UNITED STATES  
NUCLEAR REGULATORY COMMISSION  
WASHINGTON, D.C. 20555-0001

SUBJECT: H. B. ROBINSON STEAM ELECTRIC PLANT, UNIT NO. 2 – STAFF REVIEW OF SEISMIC PROBABILISTIC RISK ASSESSMENT ASSOCIATED WITH REEVALUATED SEISMIC HAZARD IMPLEMENTATION OF THE NEAR-TERM TASK FORCE RECOMMENDATION 2.1: SEISMIC (EPID NO. L-2019-JLD-0022)

Figure 1. Comparison of the Ground Motion Response Spectrum (GMRS) from the re-evaluated hazard and the Safe Shutdown Earthquake (SSE) for Robinson

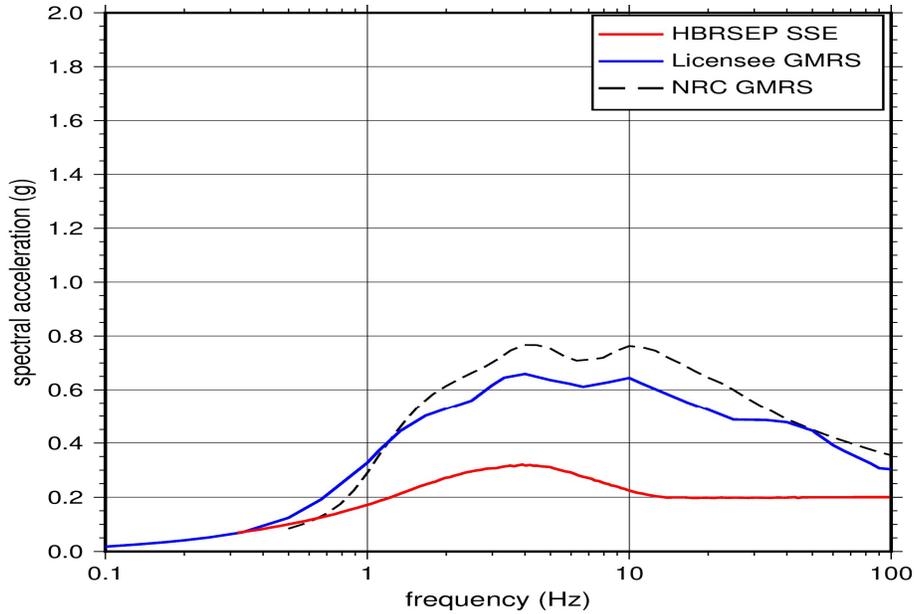
Table 2 also provides failure probabilities at the seismic acceleration of 0.3g because that acceleration is the PGA for the re-evaluated hazard as shown in Figure 1. It is evident from Table 2 that the dominant risk contributors listed above have non-trivial failure probabilities even at the acceleration corresponding to the plant's SSE. Non-trivial failure probabilities of SSEs at these accelerations are particularly significant due to relatively high frequency of earthquakes at those accelerations. The failure probability for the Robinson dam, which is the plant's Ultimate Heat Sink (UHS), is approximately 12 percent at the acceleration corresponding to the plant's SSE.

The acceleration of 0.3g is the PGA for the GMRS based on the re-evaluated hazard. The reevaluated hazard and the resulting GMRS represents the seismic hazard at the plant based on the best available knowledge and technology. The failure probability and resulting impacts from the above-mentioned dominant risk contributors increases, in several cases above 50 percent, at the acceleration of 0.3g. Those failure probabilities represent a further degradation of the defense-in-depth.

Figure 2 Layout of Turbine Building at the Ground Floor Level

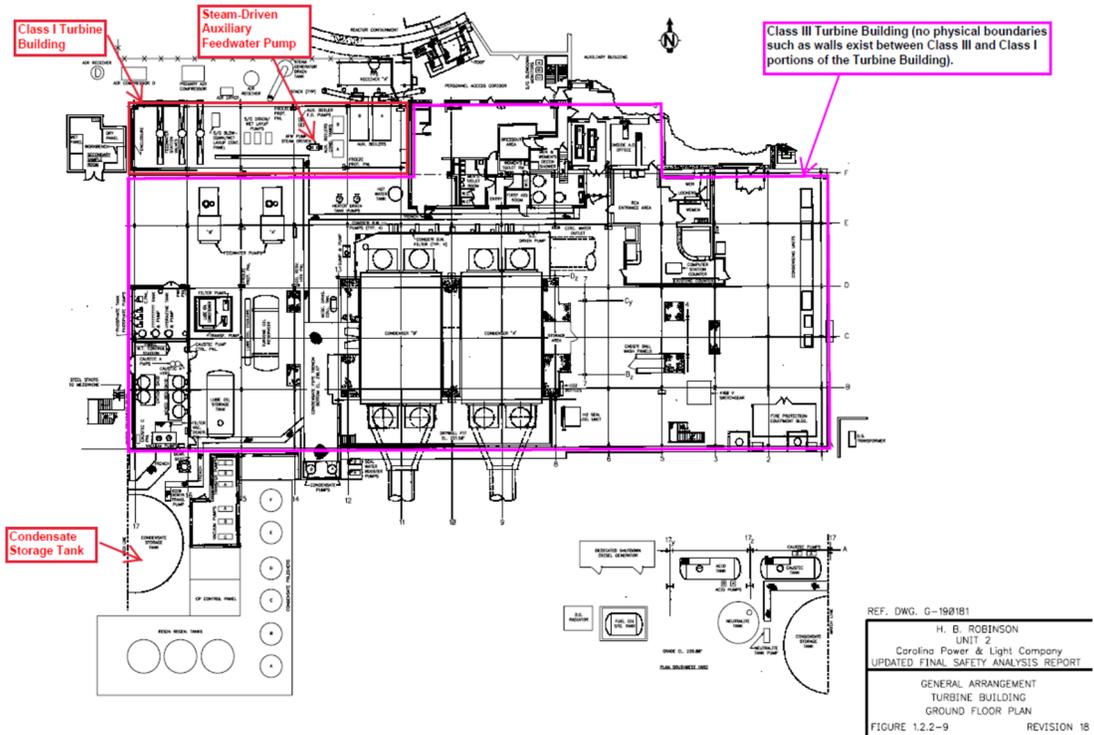
Figure 2 and Figure 3 shown the layout of the TB at Robinson at the ground and mezzanine floor level, respectively. Figure 2 and Figure 3 also identify certain SSCs relied upon for mitigation to demonstrate location and proximity to the Class III TB. Figure 4 shows a cross section of the Robinson dam.

Figure 8 Contribution of seismic vulnerabilities to the risk from each 'bin' in the SPRA

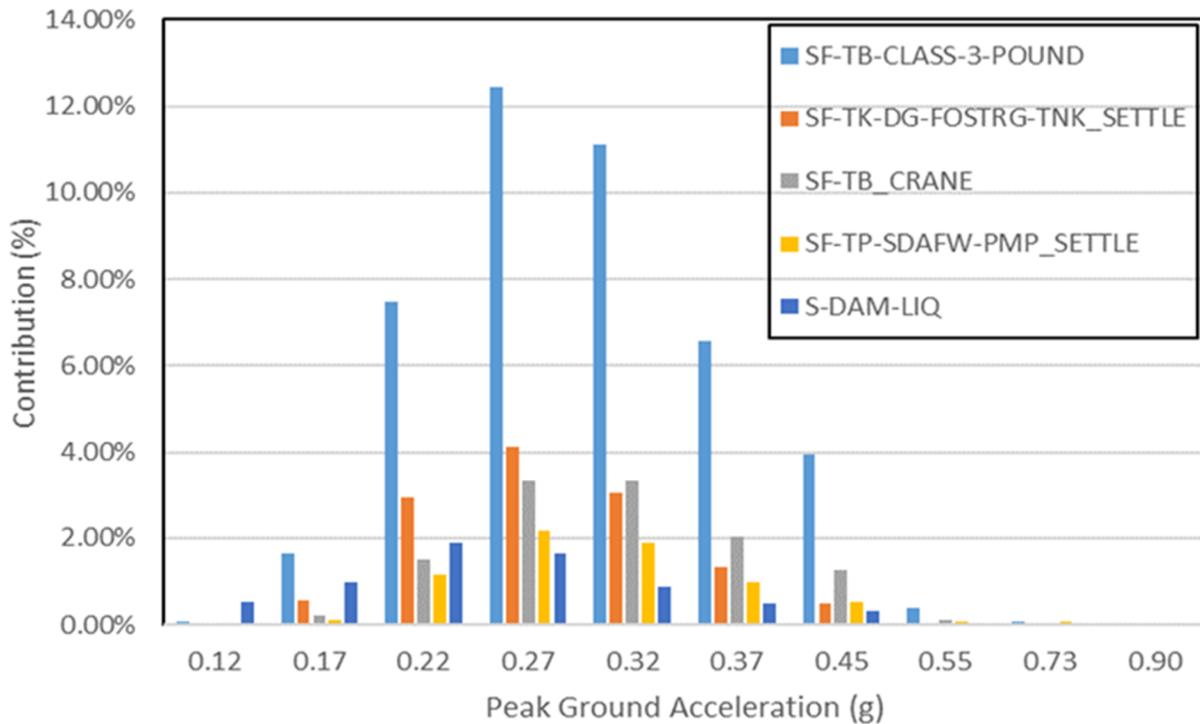
Figure 8 shows the contribution of each of the dominant risk contributors to the total SCDF at different PGA values, which correspond to the seismic 'bins'<sup>8</sup> in the SPRA. Figure 8 shows that the seismic vulnerabilities have non-negligible contributions (i.e., impact the plant response) across the seismic accelerations considered in the SPRA, including low seismic accelerations such as 0.17g through 0.4g. These seismic accelerations have a return period of 1 in 2000 years (for 0.17g) through 1 in 19,000 years (for 0.4g). As shown in Figure 13, these results are markedly different from those reviewed by the staff for several SPRAs submitted in response to the 50.54(f) letter, where the contribution of the dominant risk contributors is from higher seismic accelerations (e.g., 0.5g and above) which have return periods of 1 in 100,000 through 1 in 1,000,000 years.

Figure 13 Comparison of conditional core damage probability as a function of seismic acceleration for Robinson against several other operating plants

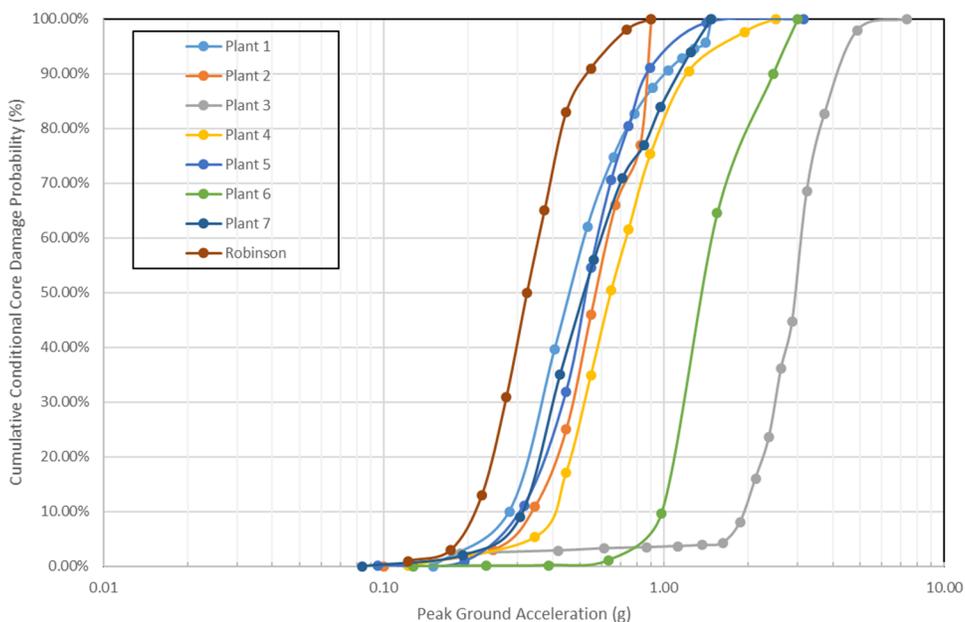
Figure 13 and Figure 14 compares the cumulative contribution to SCDF and SLERF, respectively, from Robinson's SPRA against seven different plants that have submitted SPRAs in response to the 10 CFR 50.54(f) request for information resulting from the accident at the Fukushima Dai-ichi nuclear power plant. As shown in Figure 13 and Figure 14, the contribution to Robinson's SCDF is from relatively low acceleration earthquakes which is atypical. As an example, Figure 15 shows that accelerations at or below 0.32g contribute 50 percent to the SCDF for Robinson as compared to less than 10 percent for 7 other plants. In addition, if comparison is made between the contribution to SCDF from accelerations at and below the occurrence frequency of 1E-4 per year, that contribution for a west coast plant (acceleration of
